MANSFIELD ATSP FIELD OBSERVATIONS
AND RECOMMENDATIONS

MEMORANDUM

To: City of Mansfield
From: Monica Powell, AICP, RSP₁
Date: November 5, 2025
Subject: Mansfield ATSP – Field Observations and Recommendations

Figure 13. Replace Street Name Sign

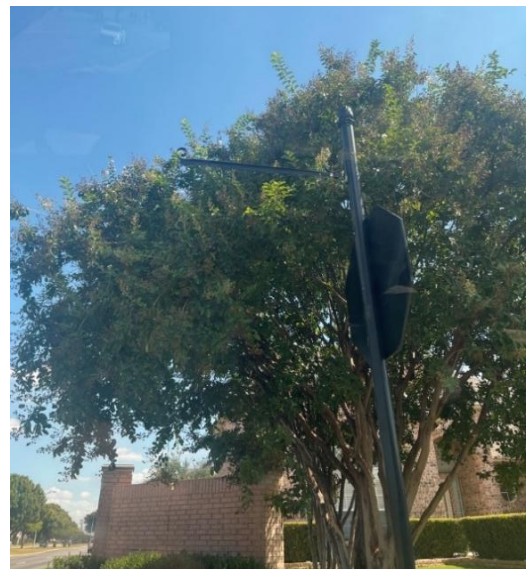
The street name sign is missing. It is recommended to replace the sign name to be more to road users for navigation. (Figure 13)

Figure 21. Clear Brick Wall

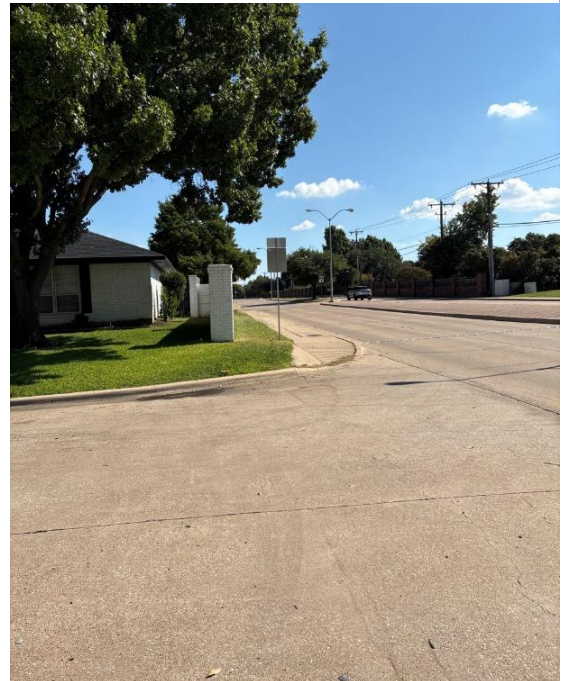
Sight distance is poor looking east. Consider moving the existing fence closer to the front corner to improve line of sight. (Figure 21)

Figure 22. Relocate Fence

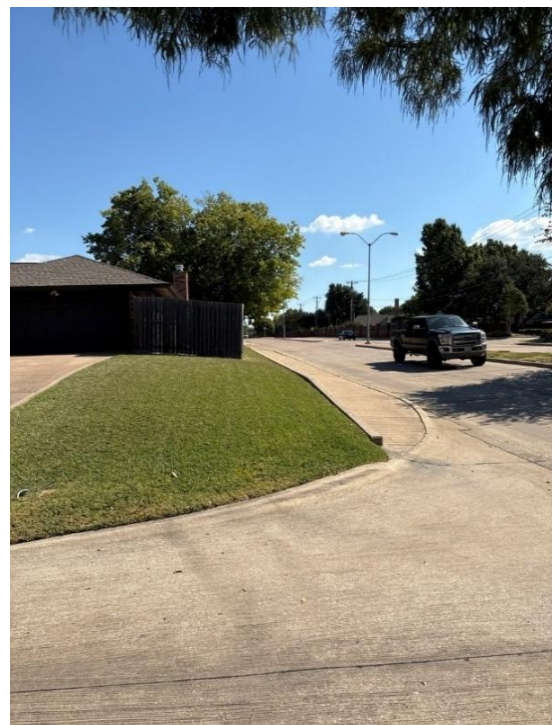
Currently there is poor sight distance at this intersection. It is recommended to relocate or clear the fence to allow for better sight distance (Figure 22)

Figure 23. Thru-Cut Intersection

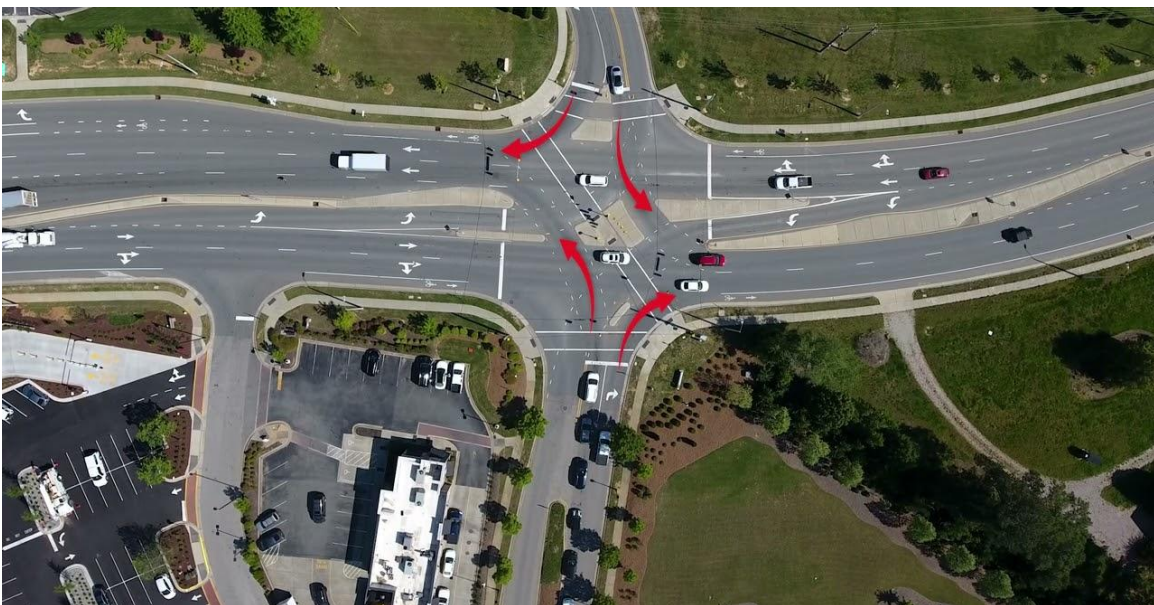
There is an existing traditional 4-way traffic signal. It is recommended to convert this signal into a signalized thru-cut intersection to prevent angled crashes. A thru-cut intersection is similar to a hooded left-turn median opening; however, it also allows left turns from the minor road.

Figure 27. Upgrade Signage to Rectangular Rapid Flashing Beacon

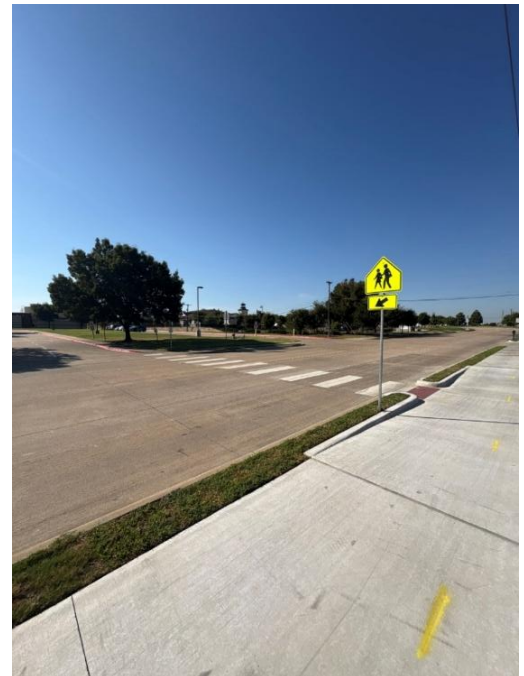
To create a safer crossing for pedestrians, it is recommended to install a Rectangular Rapid Flashing Beacon, allowing pedestrians to have a designated crossing space. Flashing beacons also draw attention to pedestrian crossings, making them more visible to motorists, especially in low-light conditions or areas with high traffic volumes such as on Cannon Dr. with a volume of 5,200. (Figure 27)
